Appeal of the Chief Building Official's Decision for a Signage Master Plan Application for 3 wall signs on a portion of the premises at 2075 Bayview Avenue

Date: January 15, 2024
To: Sign Variance Committee
From: Manager, Citywide Priorities, Toronto Building
Wards: 15 - Don Valley West

Figure 1: North elevation of the S-Wing and location of Proposed Signs

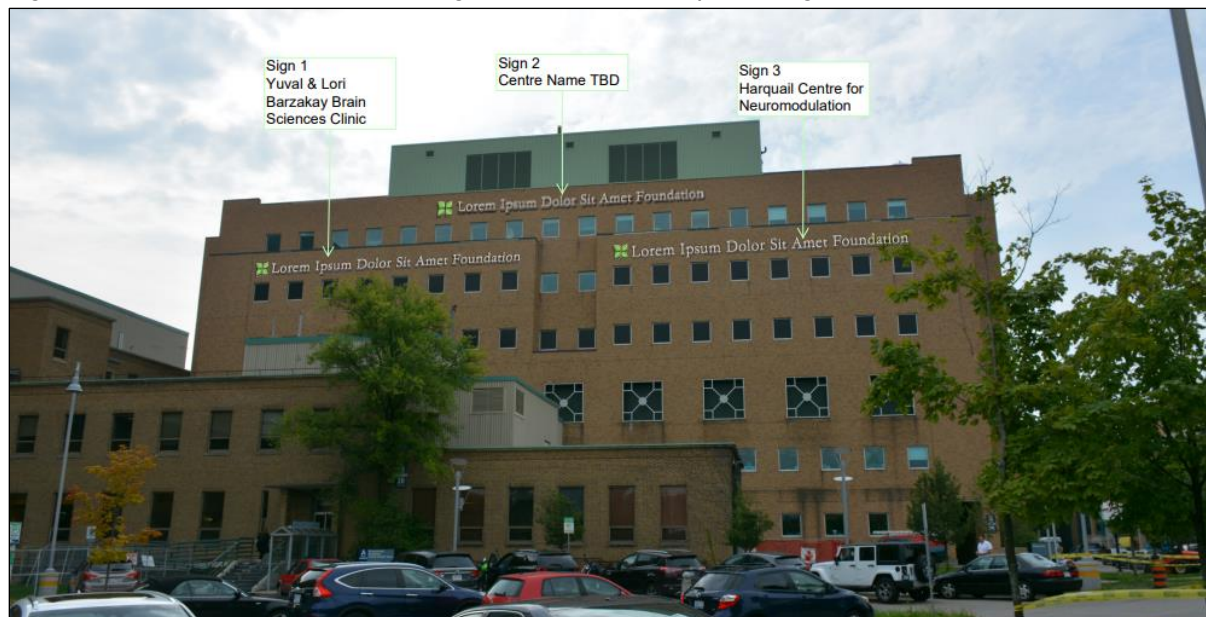
The Proposed Signage Master Plan contains 3 wall signs. All the of the Proposed Signs are first party signs and will display static copy. The CBO-Designed Signage Master Plan contains three similar first party wall signs. Both the CBO-Designed Signage Master Plan and the Proposed Signage Master Plan would be one of three separate Signage Master Plans addressing differing portions 2075-Bayview, and would include the northern elevation of the S-wing building located at 2075-Bayview, with the exception of the first storey.

SECTION Or Condition	REQUIREMENT/Details	PROPOSAL
694-21 F (4)(a)	A wall sign in an Institutional Sign District shall only be erected on the first storey.	All three of the Proposed Signs would be subject to the same variances as in the Proposed Signage Master Plan, but would be subject to the following two conditions
Condition 1	If illuminated, the sign shall not be illuminated between the hours of 11:00 p.m. and 7 a.m.	
Condition 2	If illuminated, the illumination shall not exceed 150 nits during the period between sunset and sunrise.

Figure 7: Distance from the Proposed Signs to Surrounding Properties

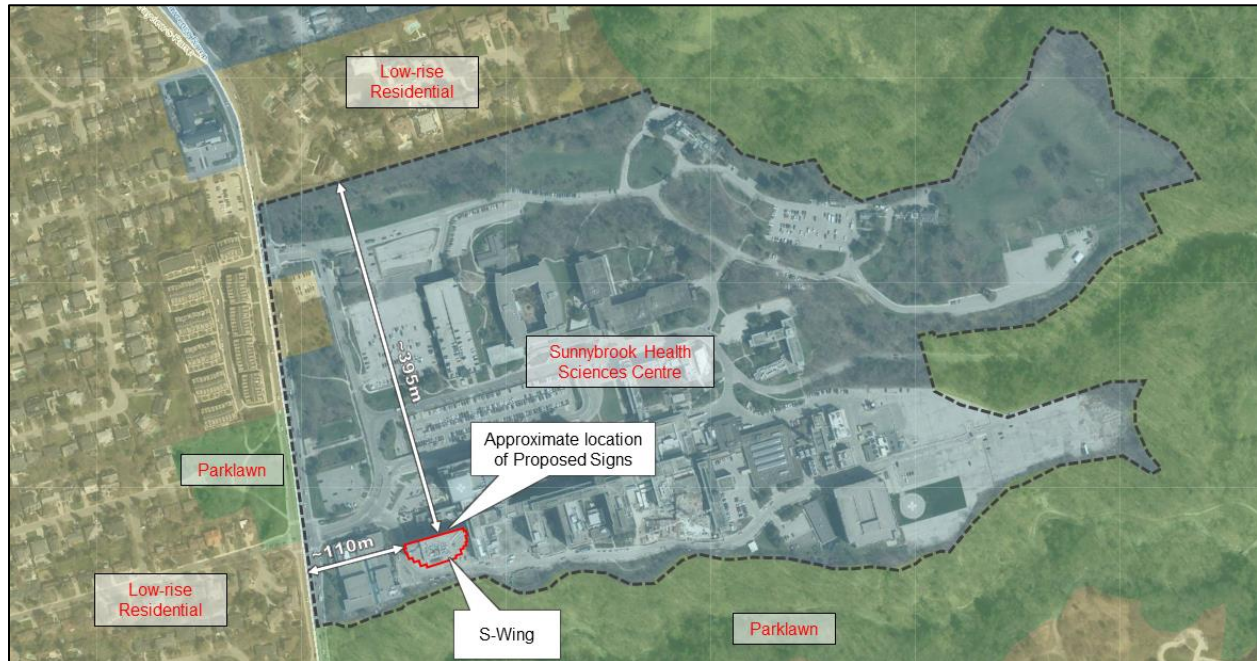
The north elevation of the S-Wing building will have some visibility off-site, mostly to vehicular traffic travelling south on Bayview Avenue. The nearest residential area, situated west of the Subject Premises, is approximately 110 metres away from the S-Wing building, where the Proposed Signs would be placed. The Proposed Signs are positioned high above ground level, and it has not been established that light trespass will not affect these properties. It cannot be established that Proposed Signs would not be visible to any residences in the surrounding area, and the Proposed Signage Master Plan has not been established as suitably mitigating any potential light intrusion concerns.

Other parties to the hearing raised concerns that illumination would adversely affect adjacent premises. The CBO in reviewing all submissions determined that if the Signage Master Plan, contained signs which were subject to conditions that they would not be illuminated between the hours of 11:00 p.m. and 7:00 a.m., and that illumination

shall not exceed 150 nits during the period between sunset and sunrise, this would mitigate any potential adverse impacts as to eliminate the possibility of adverse affects on adjacent premises.
